#### REMARKS

CISCO-3024

F16. 5

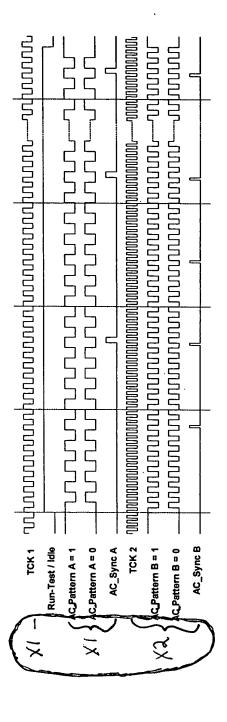
FIG. 5 stands objected to for lacking clarity with respect to the designations X1 and X2. With this paper, these designations have been given more specificity.
